Ripple and Noise

IEEE 802.3at Task Force

Anoop Vetteth

Common Mode – Worst Case

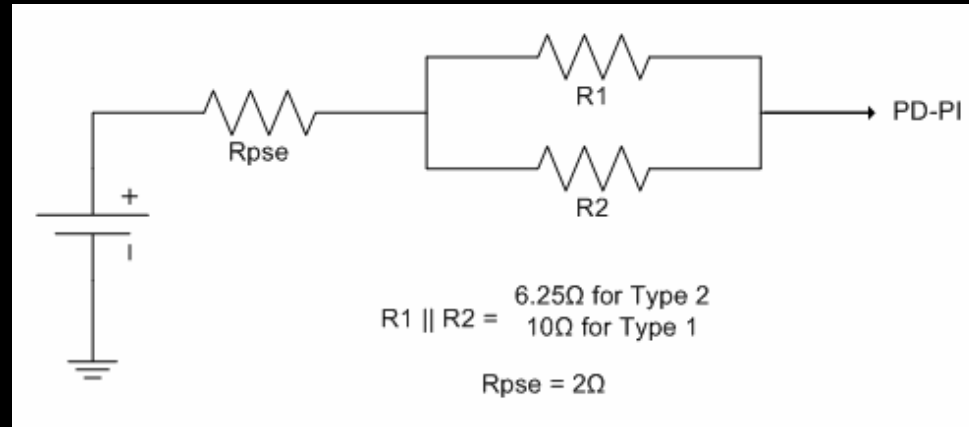
The specification for ripple and noise in Table 33-17 shall be for the common-mode and/or differential pair-to-pair noise at the PD PI generated by the PD circuitry.

Ripple and Noise	V_{pp} V	I_{pp} (Type 1) mA	I_{pp} (Type 2) mA
<500 Hz	0.5	42	61
500Hz to 150 KHz	0.2	17	24
150kHz to 500 kHz	0.15	12.5	18
500kHz to 1MHz	0.1	8	12

- Change V_{pp} in Table 33-17 to I_{pp} as shown in table on slide 3 of this presentation
- Maximum permissible transient current for a PD is $2.4\text{mA}/\mu\text{s}$

Differential Mode – Worst Case

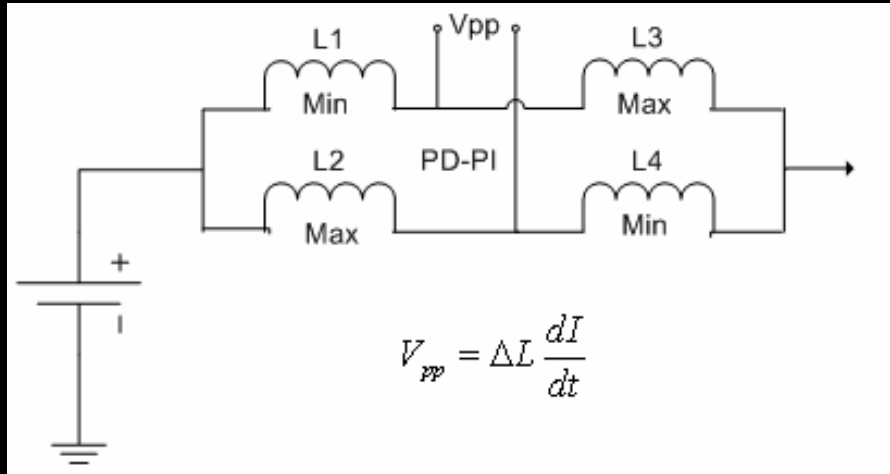
$$OCL(\max) = 1.4\text{mH}$$

$$\Delta L(\max) = 3\% \text{ of } 0.7\text{mH}$$

$$= 0.021\text{mH}$$

$$di/dt(\max) = 15\text{mA/us}$$

$$V_{pp}(\max) = 0.021\text{mH} \times 15\text{mA/us} = 0.315\text{V}$$

$0.315\text{V} >$ Permissible V_{pp} for 500Hz to 1MHz

Permissible max V_{pp} for any freq = 0.1V

Margin to account for di/dt caused by transient at PSE = 50%

$$di/dt(\max) \text{ for ripple current} = 0.1\text{V} \times 50\% / 0.021\text{mH} = 2.4\text{mA/us}$$
